ADDENDUM NO. 4

PROJECT INFORMATION			
Owner:	DBHDS	Owner's Project Mgr.:	Tom Ashworth
Project Title:	CSH Buildings 94 & 95 HVAC Systems Replacement	Owner's Project Code:	720-17596-03-01
Project Location:	Petersburg, Virginia	DGS Project Code:	720-17596-011
IFB No.	11-15	A/E Project Mgr.:	Steve Hovis, PE
Bids Due:	November 16, 2011 / 2:00 PM	A/E Project No.:	09011
		Bids Opened:	November 17, 2011 / 2:00 PM

Central State Hospital Buildings 94 & 95 HVAC Systems Replacement

BUILDING 39 PARTIAL ELECTRICAL PLAN
SCALE: 3/16"=1'-0"

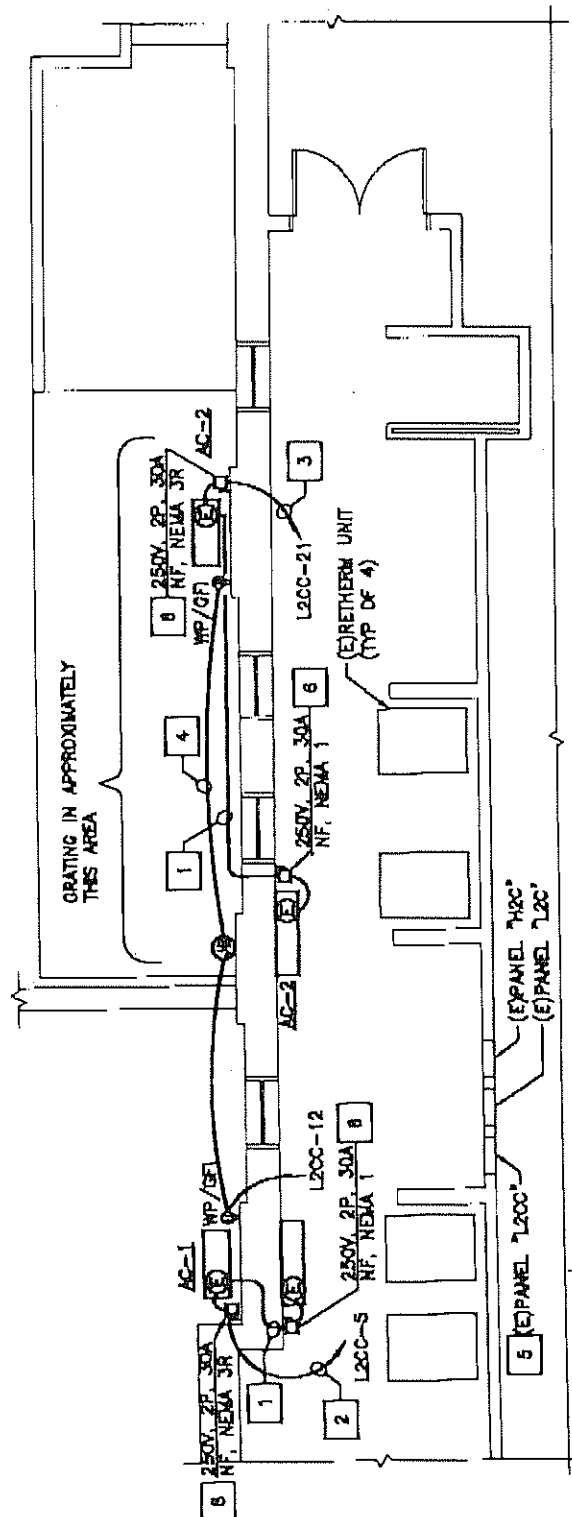
- a. Provide two ductless mini split system air conditioners in access corridor in Building 39 near rethermalization units. Refer to attached sketches. Specification 238123 applies to these units.
- b. Specification 238128, Split System Ductless Air Conditioners:
 1. In Paragraph 2.1.C, delete requirement for discharge louvers with automatic air sweep control.
 2. In Paragraph 2.1.F, add requirement for wall-mounted control panel to be hard-wired.
 3. Delete Paragraph 3.5.C requiring two follow-up site visits after Substantial Completion.
 4. Add Paragraph 3.2.E to read "Condensing Unit Mounting: Install ground mounted units on field-furnished or manufacturer-furnished housekeeping pad, but no less than 6 inches above grade. Install wall mounted units using manufacturer-furnished wall mounting bracket."

1. ROUTE LOW ALONG EXTERIOR WALL. TURN UP WALL AND PENETRATION BACK OF INTERIOR DISCONNECT SWITCH.
2. ROUTE EAST ALONG WALL, BELOW WINDOW. PENETRATE SALLY PORT WALL AND THEN DOWN THROUGH GRATING TO BASEMENT.
3. ROUTE WEST ALONG WALL BELOW WINDOWS. TURN DOWN THROUGH GRATING TO BASEMENT.
4. ROUTE ALONG WALL BELOW WINDOWS TO JUNCTION BOX. FROM JUNCTION BOX TURN DOWN THROUGH GRATING TO BASEMENT.
5. SEE SKETCH SK3 AND SK4 FOR MODIFICATIONS TO (E)PANELBOARD "L200".
6. REFER TO DETAIL ON DRAWING SK5 FOR PLACEMENT AND CONNECTION OF MAINTENANCE DISCONNECT SWITCH.

ADDENDUM NO. 4
BUILDING 38
PANEL SCHEDULE "L2CC" MODIFIED
AND LOAD ANALYSIS

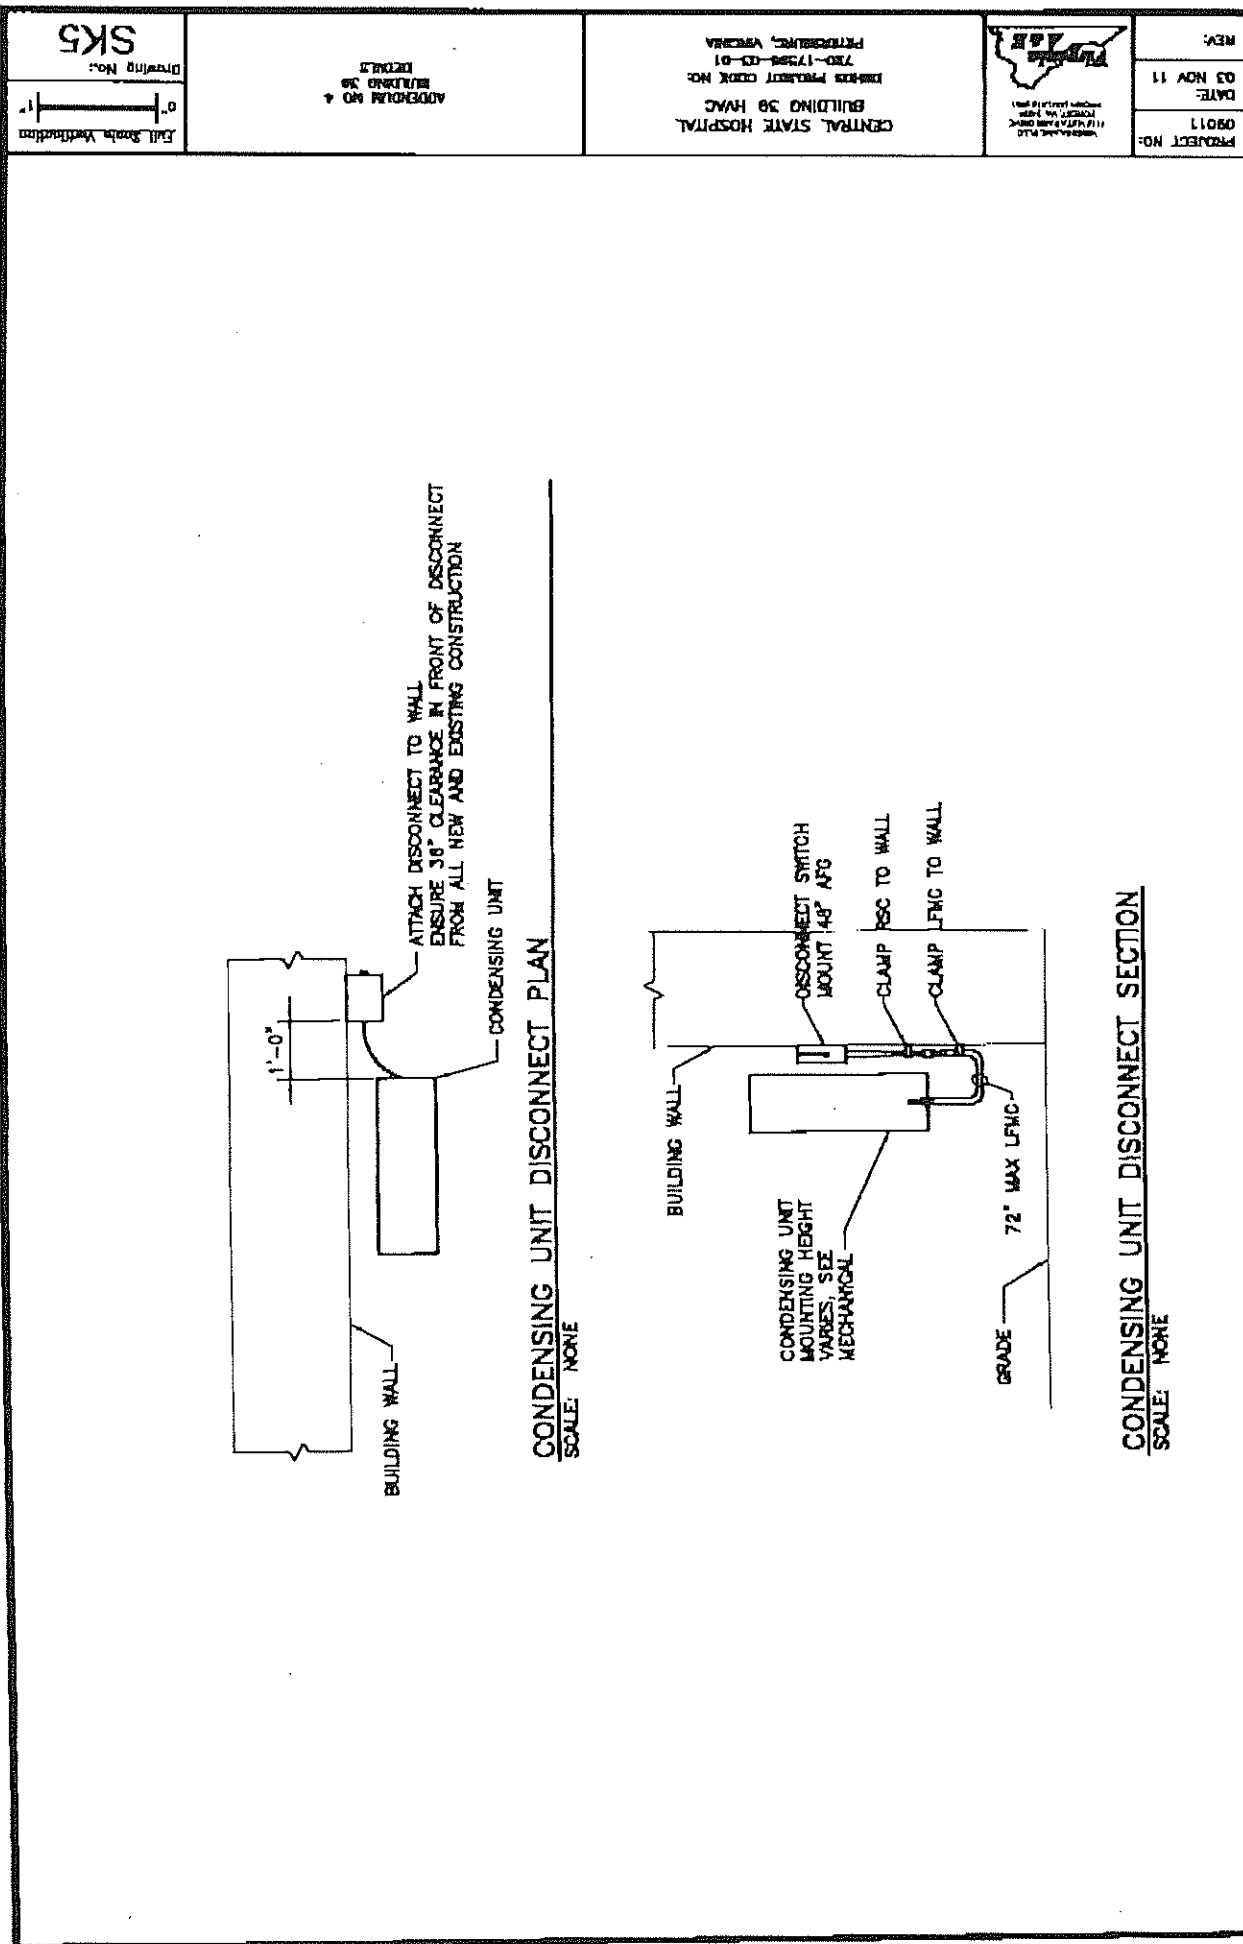
1. PANEL L2CC IS 100A MLO AND IS FED FROM A 100A 3-POLE BREAKER FROM PANEL L2C WHICH SITS ADJACENT TO IT.
2. CONNECTED LOAD TO L2CC INCREASES FROM 14 KVA TO 21.8 KVA (NET INCREASE OF 7.8 KVA)
3. ORIGINALLY PANEL L2C INCLUDED SIX REHEM UNITS WITH A TOTAL CONNECTED LOAD OF 87.5 KVA
4. THE REHEM EQUIPMENT WAS RECENTLY RENOVATED REDUCING IT TO FOUR UNITS WITH A CONNECTED LOAD OF 45 KVA
5. THE NET IMPACT TO PANEL L2C BETWEEN THE TWO PROJECTS IS A NET DECREASE OF 14.7 KVA
6. PANEL L2C IS 400A MCB

1. RELOCATE AND ADD BREAKERS AS NOTED.
2. AT CONCLUSION OF PROJECT, RE-BALANCE LOADS AND UPDATE PANELBOARD INDEX.
3. EXISTING PANELBOARD IS SQUARE D MDOO.
